SERVICE BULLETIN

BULLETIN NO: SBUS000149-26

TITLE: LTA-4 Jupiter Update

PRODUCT SERIES / MODEL: RGE16A1-03 Rail Grinder

FIGURE 1
DUST COLLECTOR TEMPERATURE PANEL

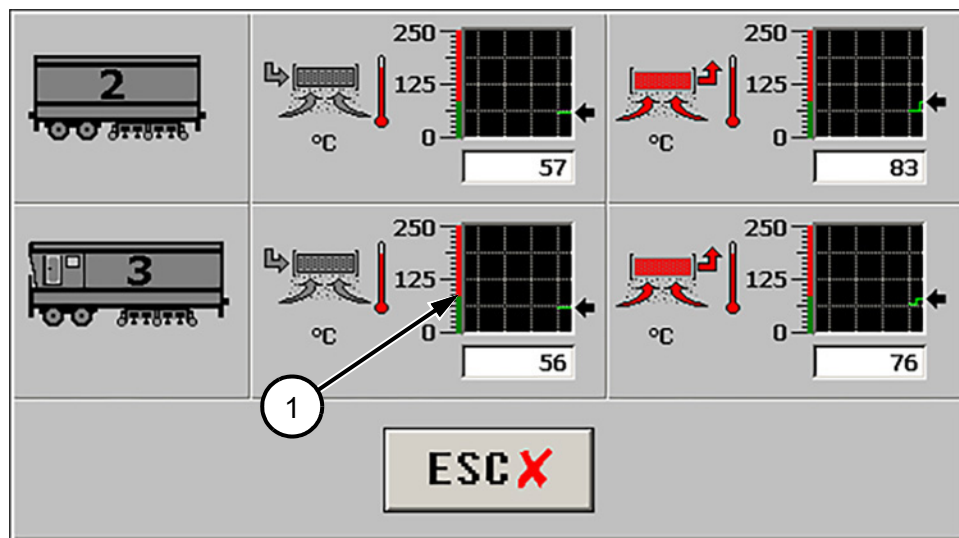
1. - See Figure 1 The red-zone (1) on the histogram scale for the dust collector temperature panel has been lowered to 85 °C.

FIGURE 2
TOOLBAR PANEL

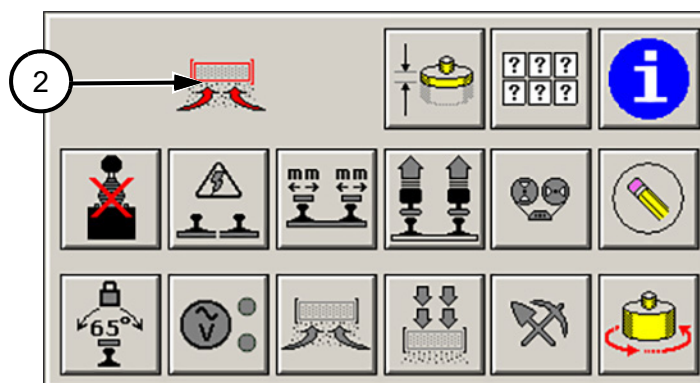
2. - See Figure 2 A blinking dust collector icon (2) is displayed on the Toolbar Panel when any reading is at or above 85 °C.
